PLANNING COMMISSION REPORT
Consent Agenda - Non-Public Hearing Item

PC Staff Report
08/23/06

ITEM NO. 4: **FINAL PLAT FOR OREGON TRAIL ADDITION; N OF US HWY 40
& E OF GEORGE WILLIAMS WAY (MKM)**

PF-07-17-06: Final Plat for Oregon Trail Addition. The property is located North of U.S. Hwy 40 (6th Street) and East of George Williams Way (extended). This residential subdivision contains 123 single-family and multi-family residential lots. Submitted by Landplan Engineering, for Oregon Trail Holdings LC, property owner of record.

Figure 2. Location of double-frontage lots.

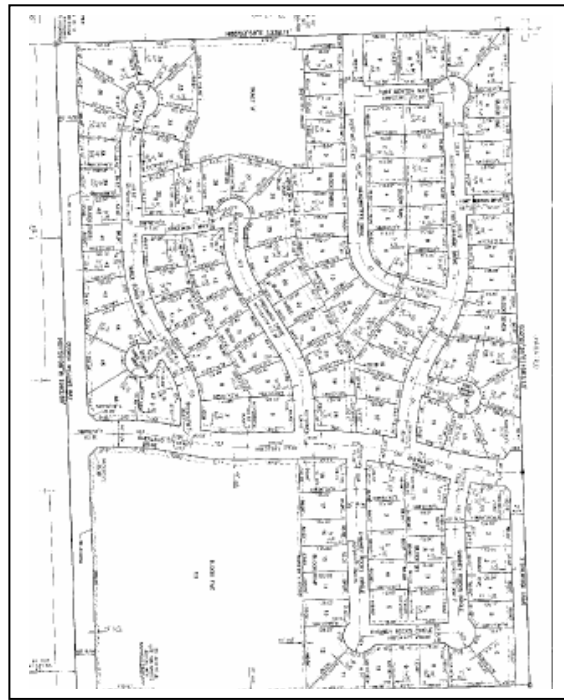
Street trees will need to be planted in both the front and rear yards of the double frontage lots. These double frontage lots are located between Three Forks Drive and George Williams Way on the west side of the development, and between Chimney Rocks Circle and Stoneridge Drive on the southeast. (see Figure 2) A landscape easement along the rear of these lots will insure space will be available for street trees. Utility easements can be shown to cross the landscape easement where necessary.

The proposed subdivision is in conformance with the minimum lot area and dimension requirements for the RS7 (Single-Dwelling Residential), RM12 (Multi-Dwelling Residential), and the RM12D (Multi-Dwelling Residential Duplex) Districts. The plat is in conformance with the Land Development Code. Staff recommends additional pedestrian easements to increase walkability and connectivity of the area and landscape easements along the rear of the double frontage lots to accommodate the planting of street trees.

- c. 10' landscape easements must be provided on the rear of double frontage lots.
 - d. Pedestrian easements provided in Block Three between Lots 26 & 27 and along the southern border of Tract 'A' and continuing on between Lots 5 & 6, all of Block Three.
